**PUBLIC HEARING
ITEM
Agenda Item # 6**

Subject: Resolution No. 2020-32: Appeal of a Design Review Application – 126 Mount Hamilton Avenue

Subject: Design Review Approval for a Two-Story Residence at 126 Mount Hamilton Avenue

SITE PLAN

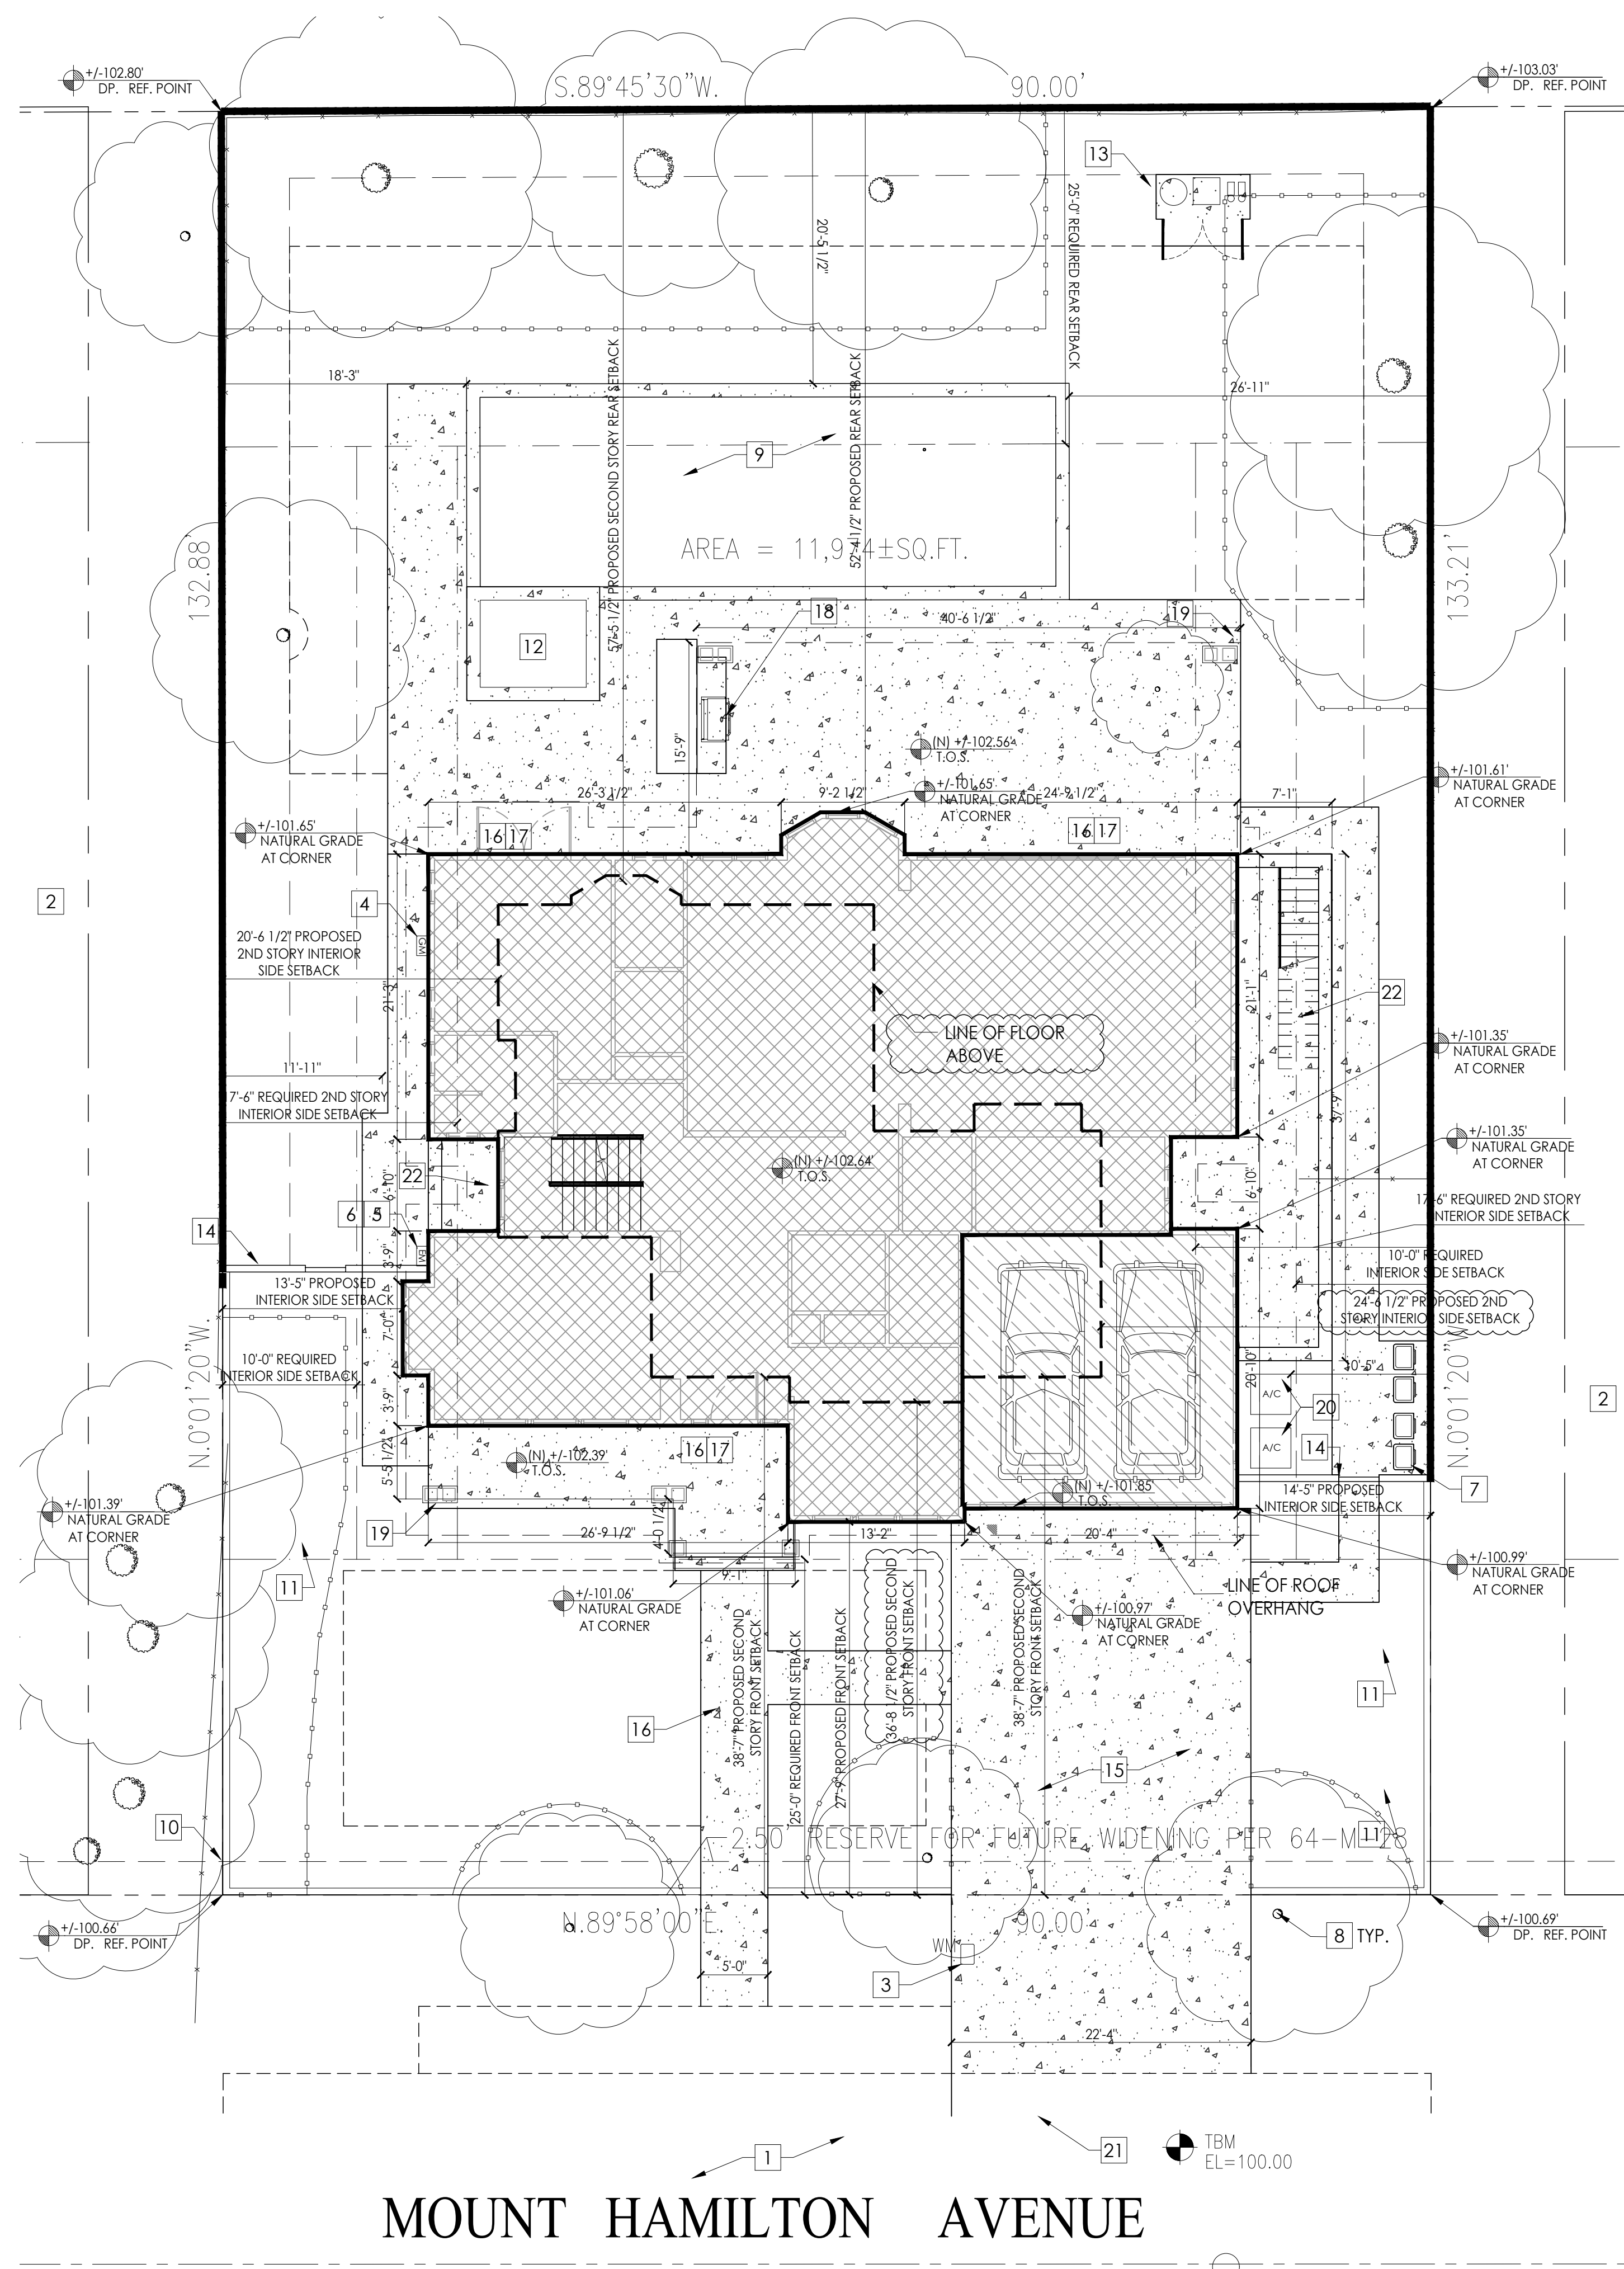
On the Site Plan, show all tree protection fencing around Trees Nos. 1-8, 10, 12-15, and 17-19 and add the following note: "All tree protection fencing shall be chain link and a minimum of five feet in height with posts driven into the ground."

Show the location of any air conditioning units on the site plan including the model number and manufacturer of the units. Provide the manufacturer's specifications showing the sound rating for each unit. The air conditioning units must be located to comply with the City's Noise Control Ordinance (Chapter 6.16) and in compliance with the Planning Division setback provisions. The units shall be screened from view of the street.

Second Story Floor Plan / October 2019

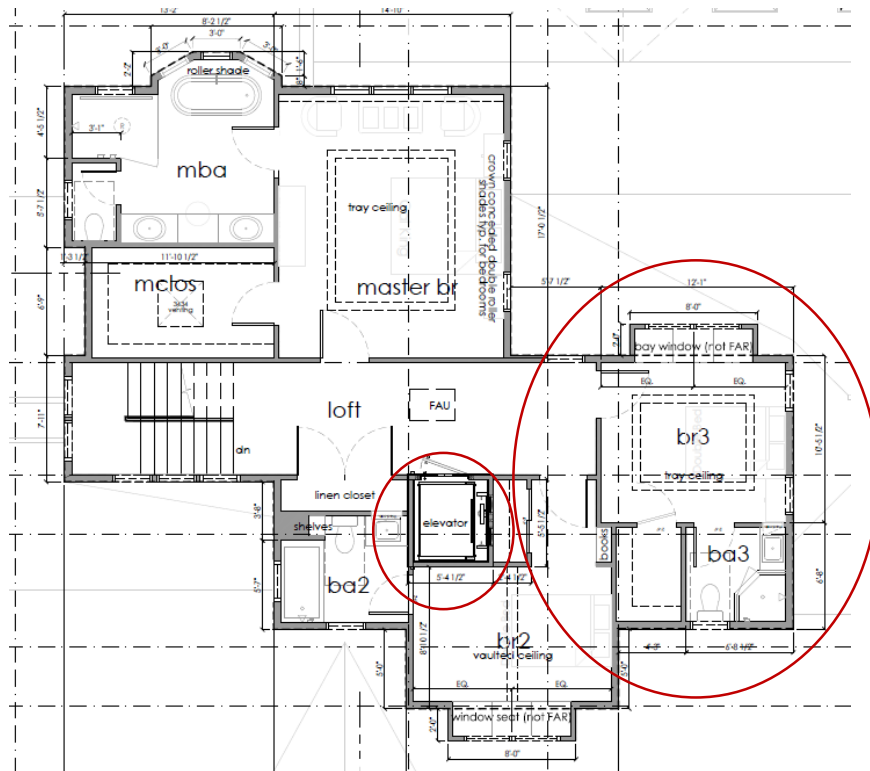
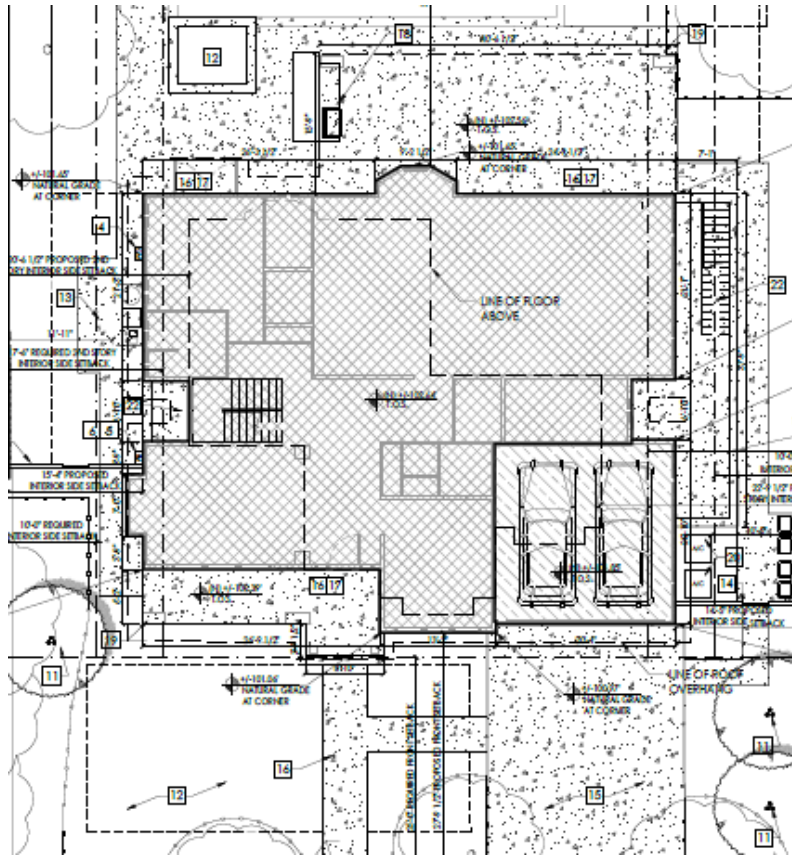
Modification: Bedroom #2 was pushed back 3 feet to reduce visual mass; Bedroom #3 was changed to be rear facing to reduce the amount of front-facing glazing; an elevator was added to service all levels.

West Elevation (Right Side) / October 2019

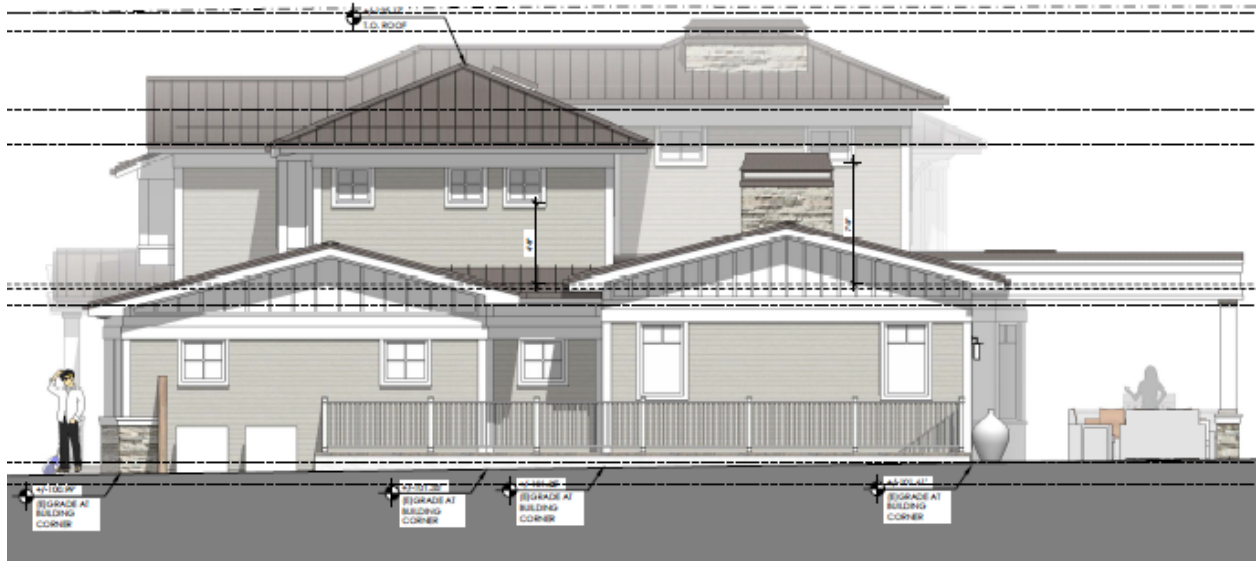
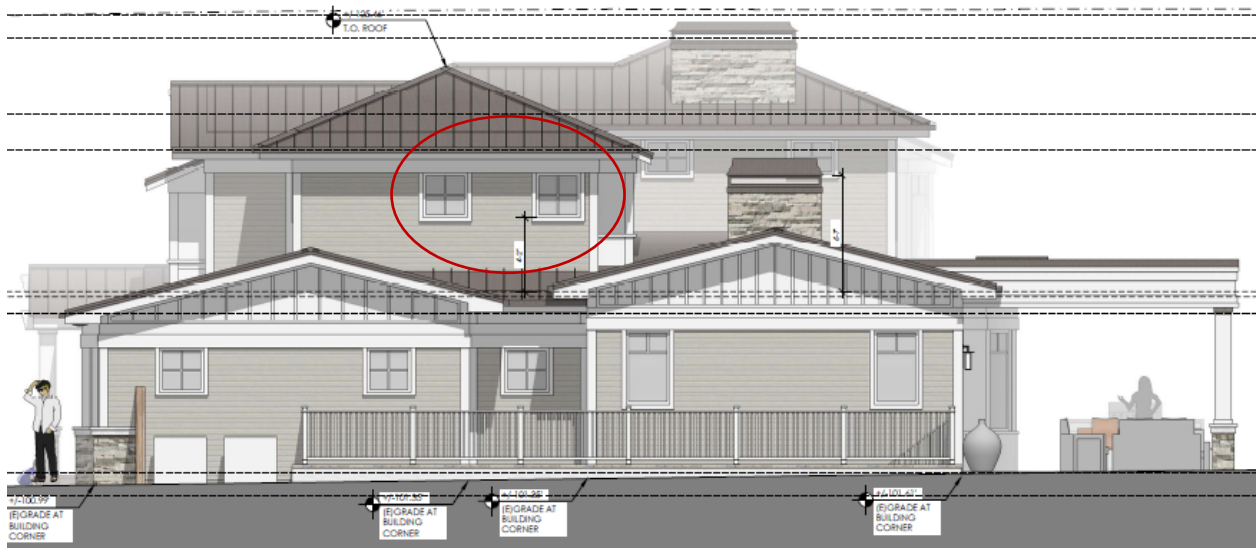
Modification: The number of windows on the West Elevation was reduced; the second story side setback was increased to 23.8 feet, where 17.5 feet is required in a R1-10 District.

Rear Elevation / October 2019

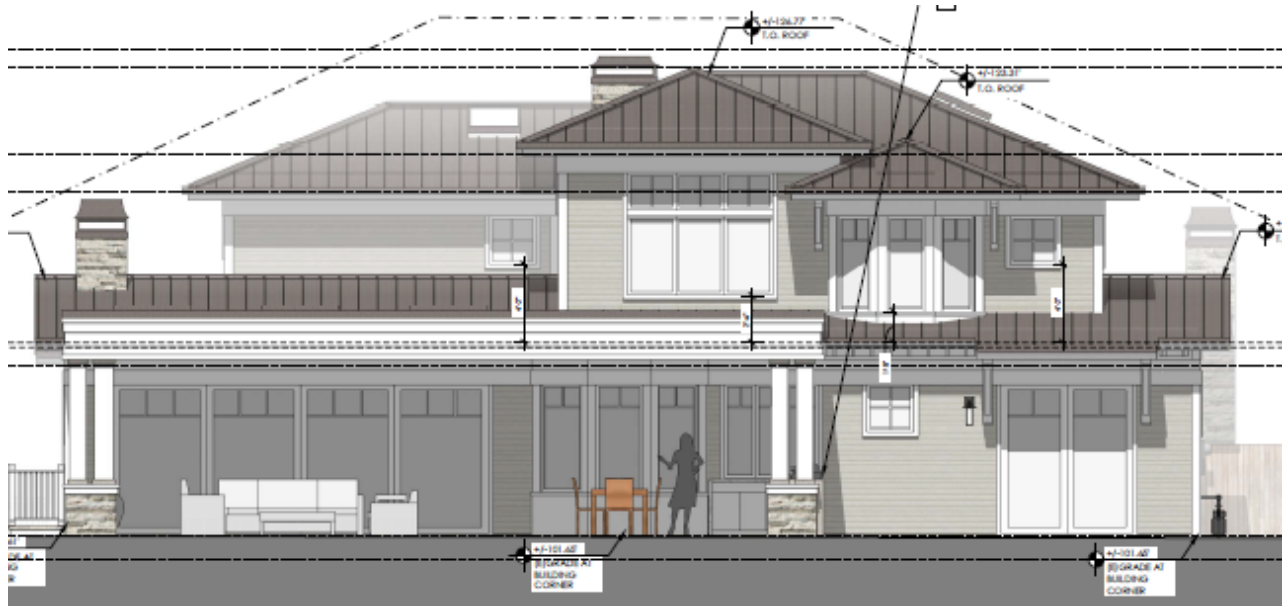
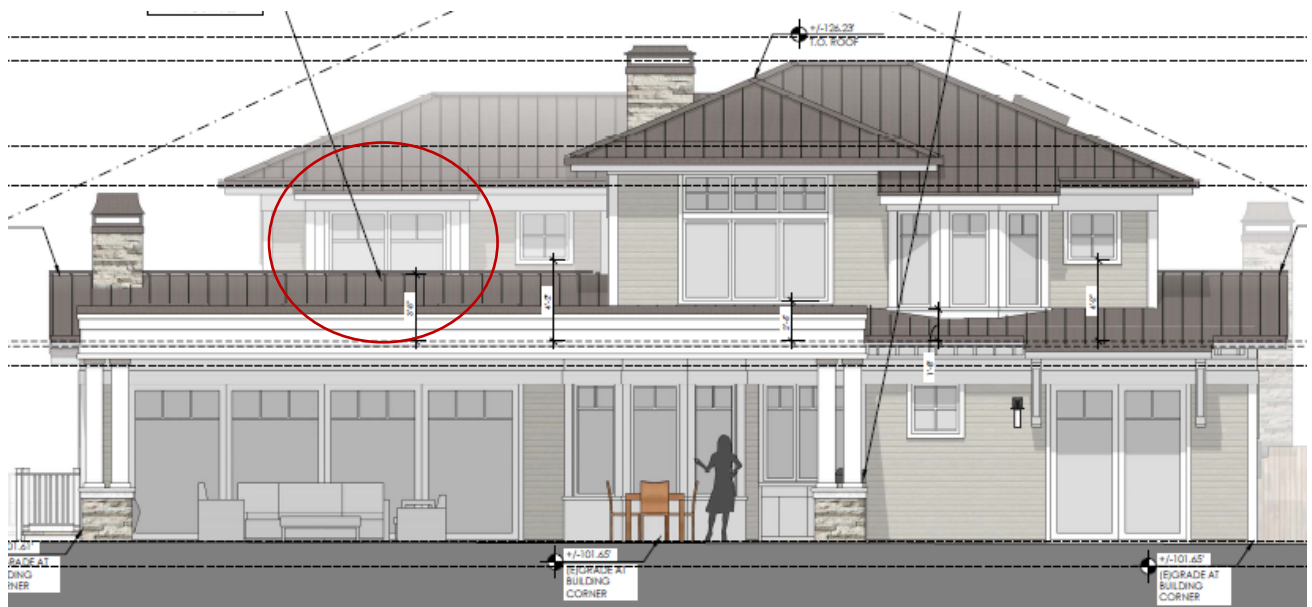
Modification: The bay window in Bedroom #3 was moved to the rear elevation; however, the project proposed an increased rear yard setback of approximately 52.4 feet, where a setback of 25 feet is required in a R1-10 District.
